From: [Hall, Brittany, EMNRD](#)
To: [Barnhill, Amy](#)
Subject: RE: [EXTERNAL] Amoco Federal 11 CTB - Post-Excavation Sampling Plan
Date: Thursday, December 19, 2024 8:01:00 AM

Post-Excavation Sampling Plan

Amoco Federal 11 CTB
New Mexico Oil Conservation Division (NMOCD)
Incident ID No. nAPP2216547154

Post-Excavation Sampling Plan

**Proposed Post-Excavation
Sampling Plan Location Map**

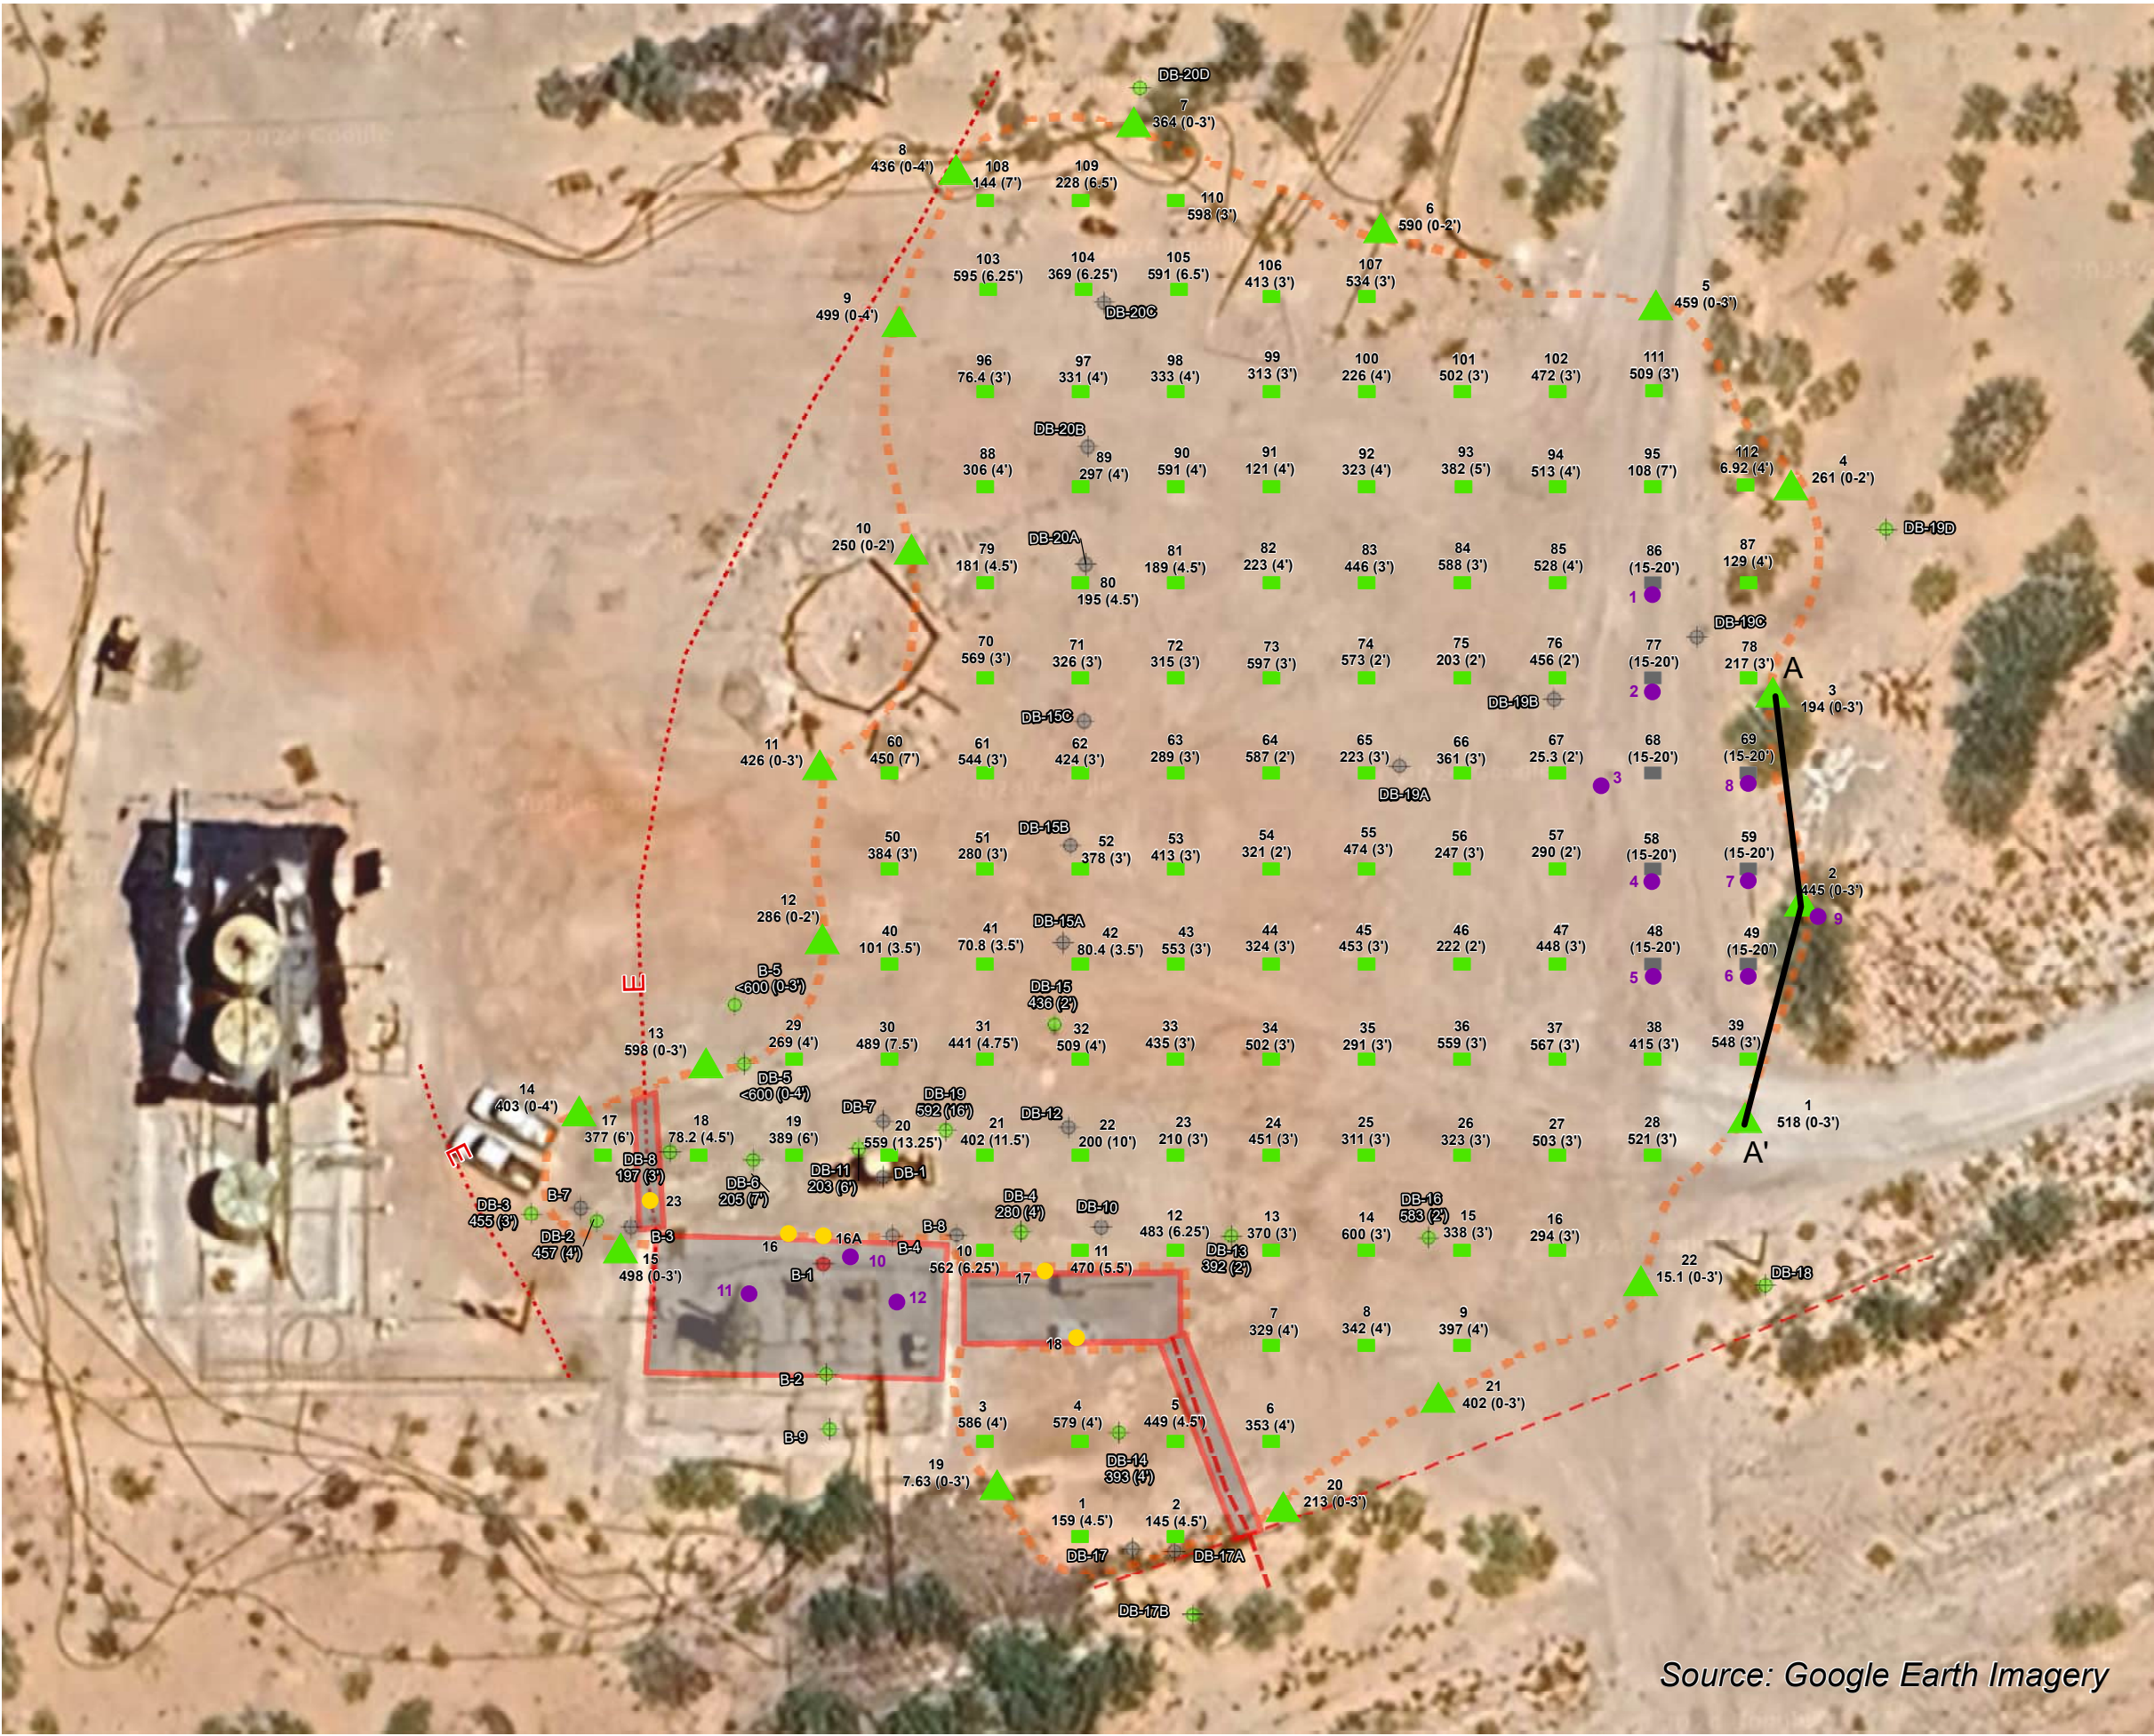
To further evaluate areas of the Site in question, based on OCD comments, additional drilling and sampling is being proposed. **Figure 4A, 4B** and **4C** present the proposed additional locations, and the following **Table A** provides the sample collection and analysis plan.

In addition to the above proposed sampling table, the following is also provided to further address the OCDs comments:

The sampling plan is approved. A copy of the sampling plan and this email thread will be uploaded to the incident file. The new due date for a complete and accurate report (either a complete remediation closure report or remediation plan, which ever is applicable), is due by 2/28/2025.

AECOM AMOCO FEDERAL 11 CTB EDDY COUNTY, NEW MEXICO			Title: EASTERN WALL CROSS-SECTION VIEW		
			Client: Chevron Environmental Management Company		
Scale: As Shown	Drawn by: PG	Date: 12/17/2024	Project No.: 60734207	Filename: Cross_Section AA.dwg	Figure: 4B

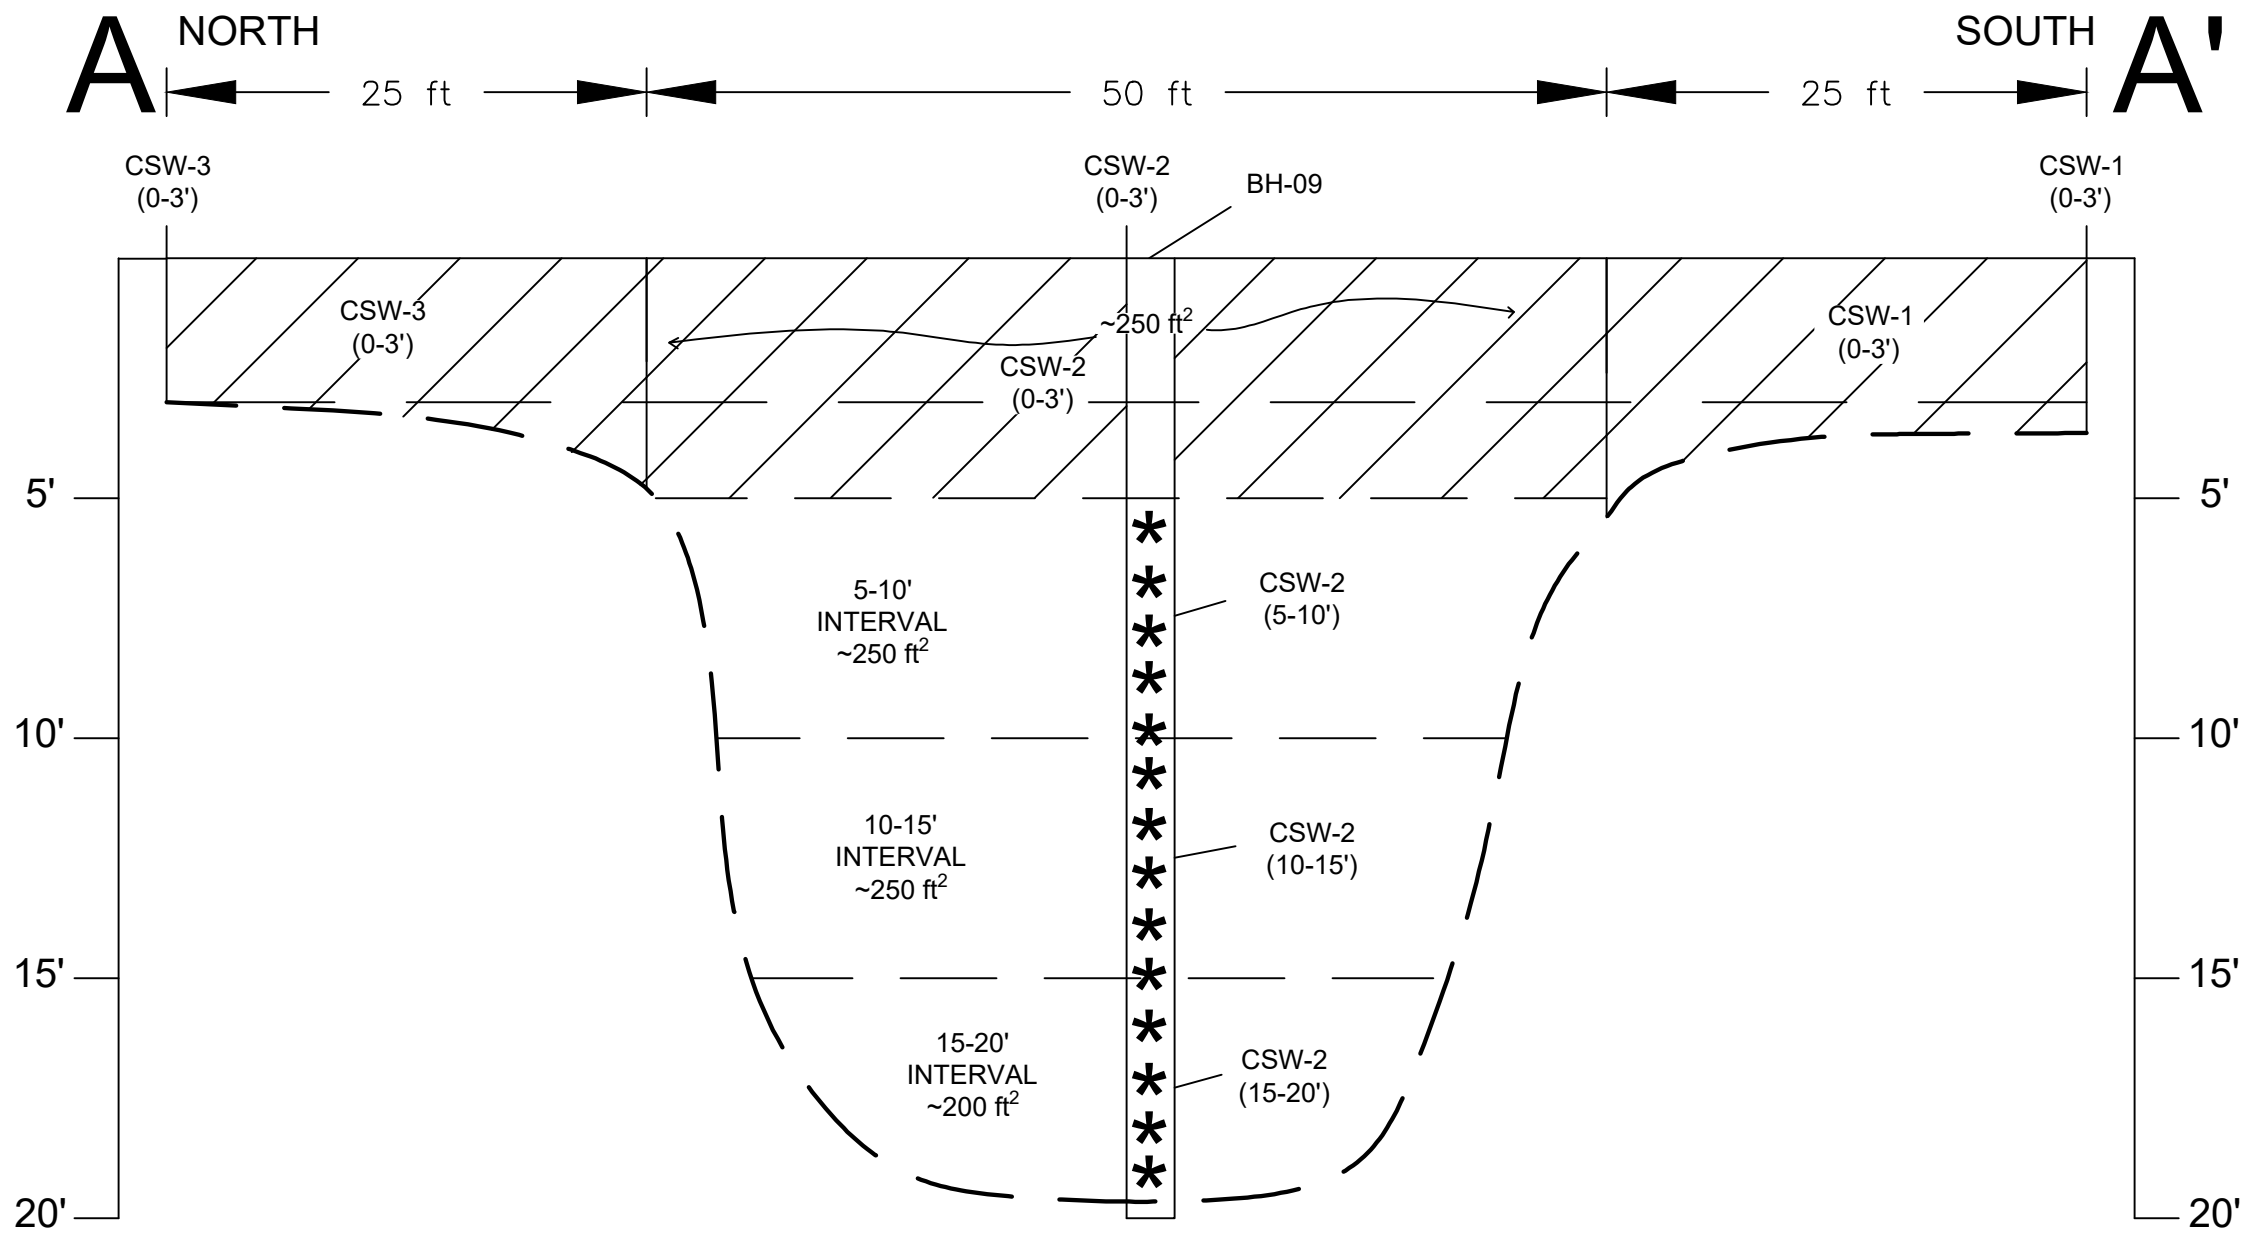
- Sample Depth Discrepancies (Eastern Area):** The OCD noted that there were discrepancies between the sample depths listed in the closure report table compared to the total depth excavated within the Eastern Area where the excavation extended down to a rock layer at approximately 20 feet. Following multiple sample depth intervals which continued to exceed the closure criteria for chloride by laboratory analysis for this area (as presented in the closure report table), several deeper samples were collected for field titration testing and which still appeared elevated. As such, rather than collecting additional lab samples and the associated delays awaiting results, this section was excavated down to the rock layer with the intention of removing any remaining impacted soil above the rock layer. The field titration data that was recorded for this area during the excavation activities are presented in **Appendix C**.

2. **Sample Collection Depths:** From our October 10th meeting, it was specifically indicated that a wall sample between CSW-2 and the deeper excavation extent nearby will be the only confirmation sample that will need to be collected. We plan to collect this sample between 10-15 feet (ft.) below ground surface (bgs) with the use of a drilling rig. **OCD requested the sampling plan to ensure that the proposed number of samples collected from this area and the method of sampling were adequate. One sample collected between 10-15 ft. is not adequate for the area of CSW-2. CSW-2 only had a confirmation sample collected from 0-3 ft bgs and the adjacent bases were excavated to 20 ft based on the information included in the rejected report.**

Proposed Background
Sample Location Map

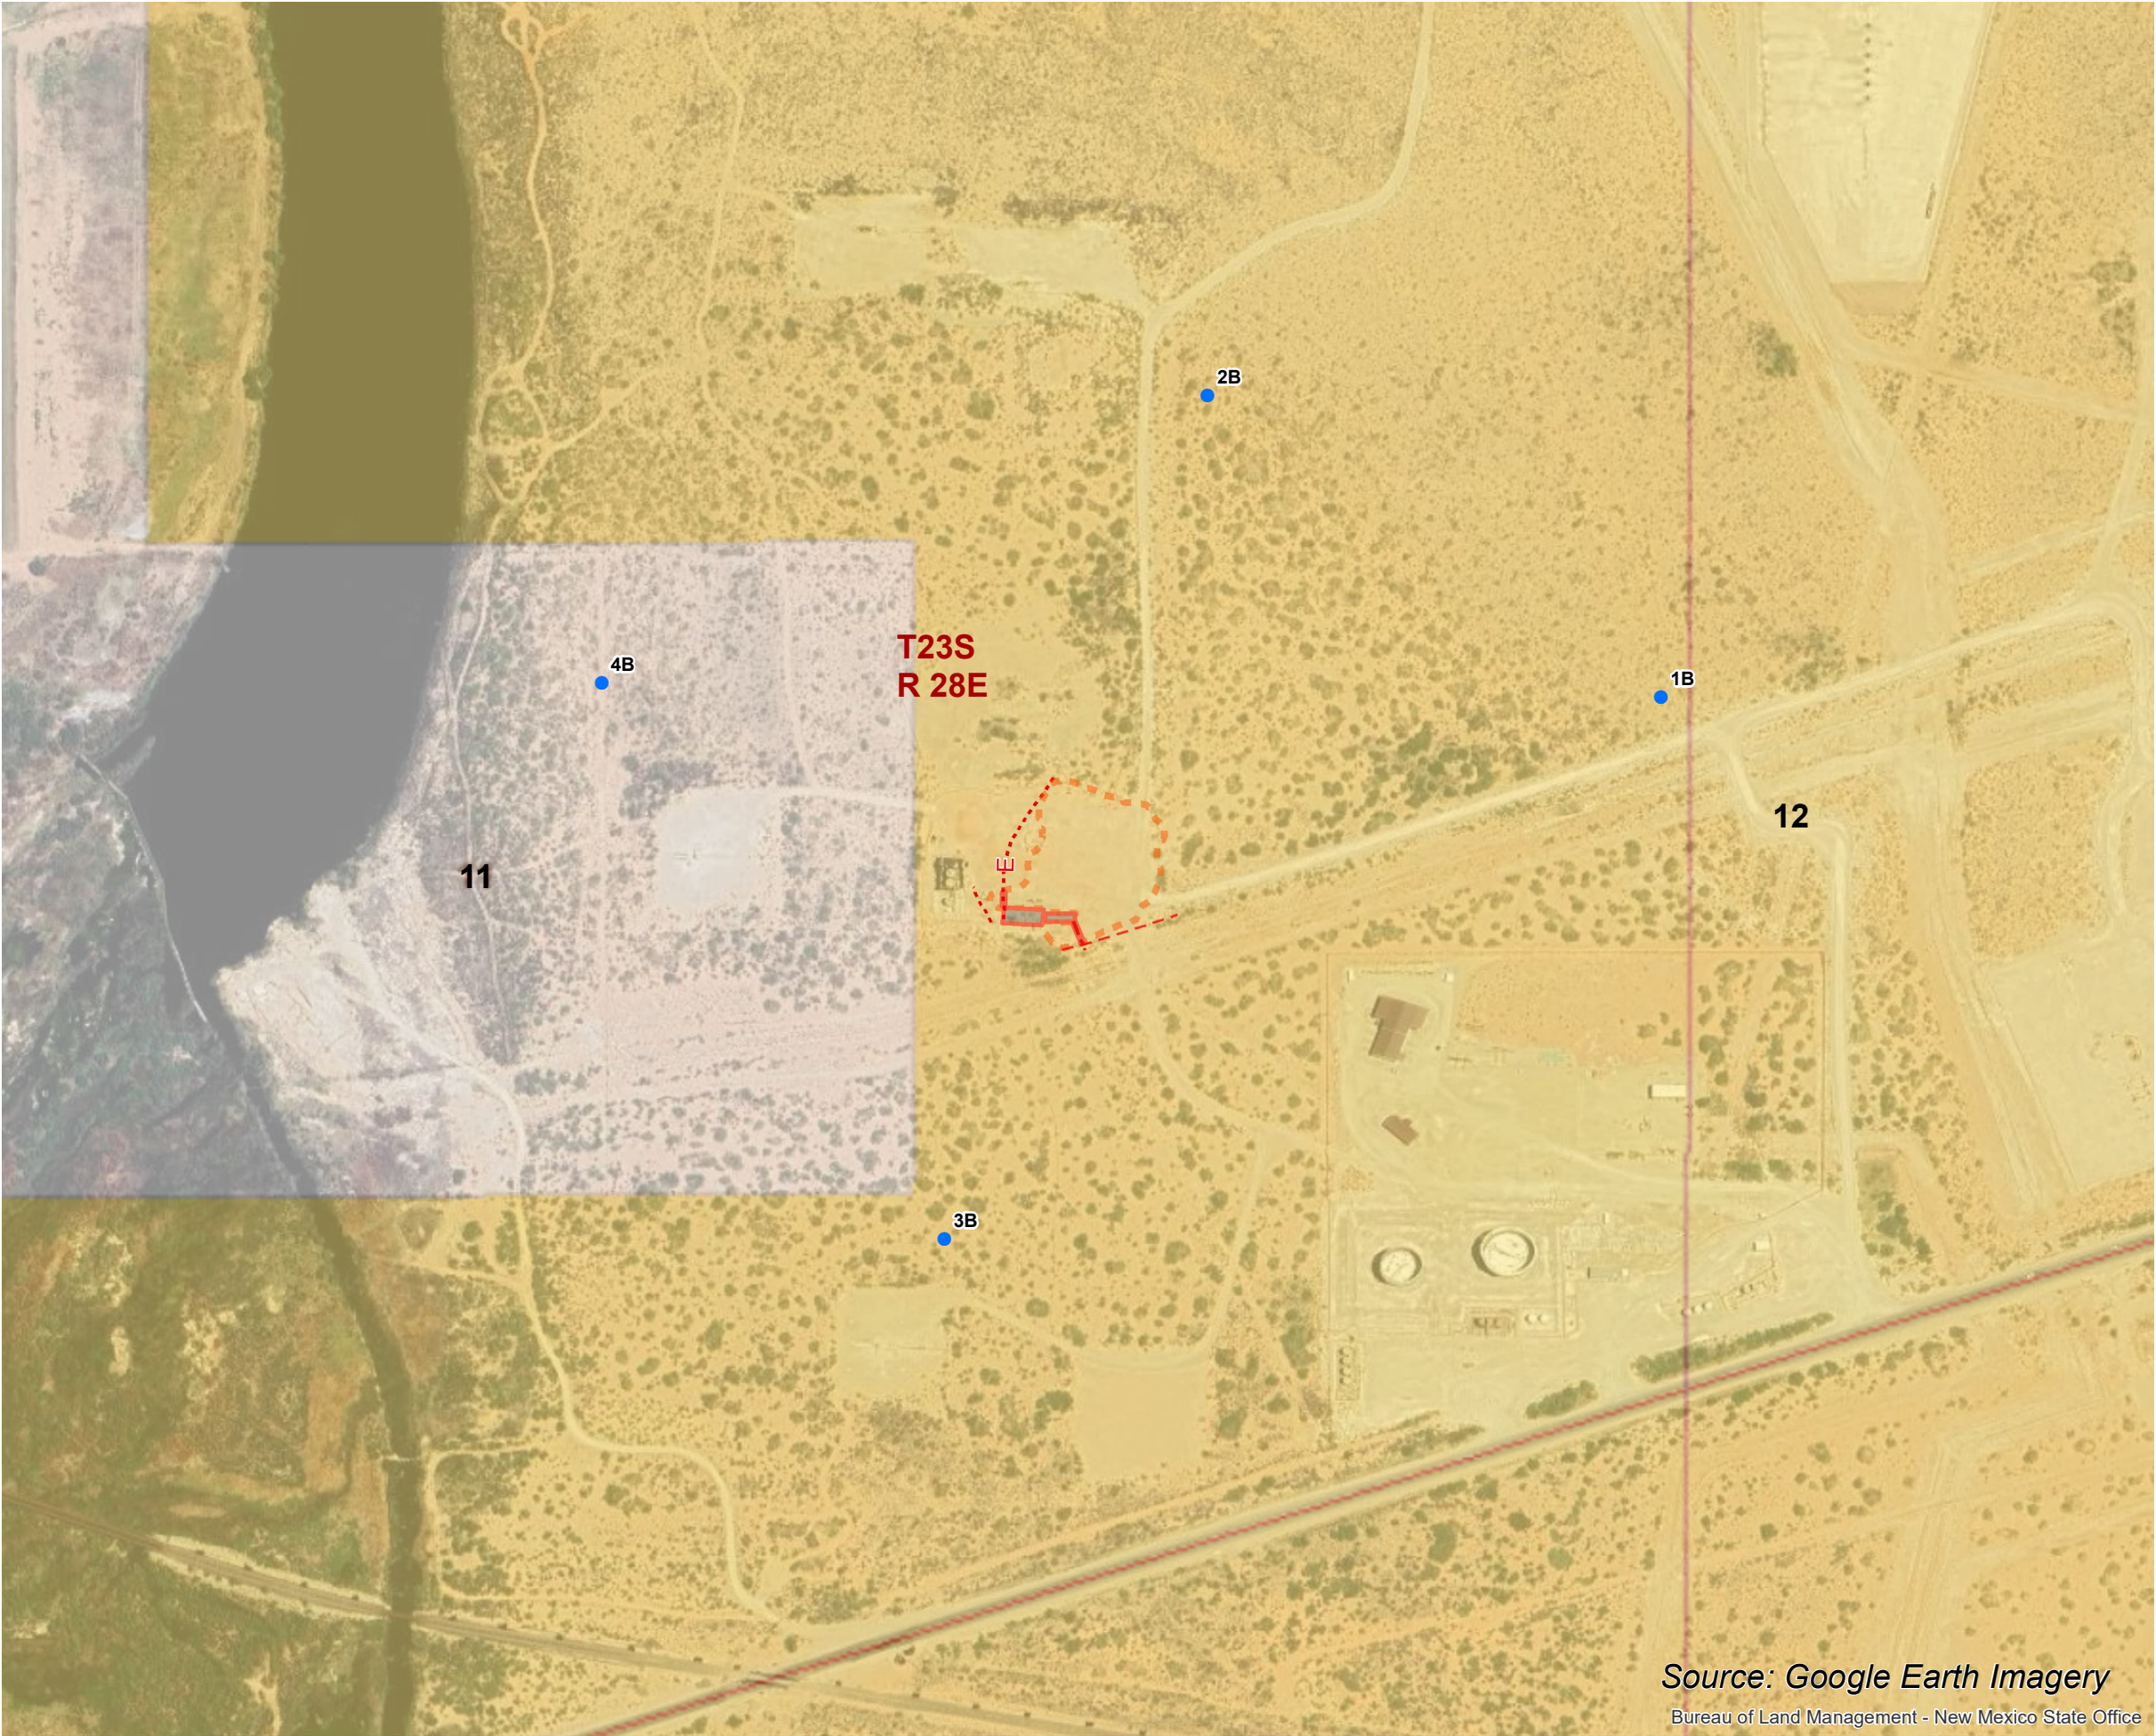
Location 3B and 4B	None	NA	Install one monitoring well in these areas for evaluation of background chloride concentrations and determining groundwater flow direction.	Assess background chloride and TDS concentrations at cross/downgradient location relative to the site. Analysis of BTEX and TPH will also be conducted. Note, location 4B is pending landowner approval.
---------------------------	------	----	---	--

In addition to addressing the listed concerns during the upcoming meeting, we would also like to discuss the possibility of drilling temporary groundwater monitoring wells. This would allow us to analyze the local groundwater for chlorides and determine the existing background levels in the area. OCD would like to review the locations of the temporary groundwater monitoring wells before they are installed.
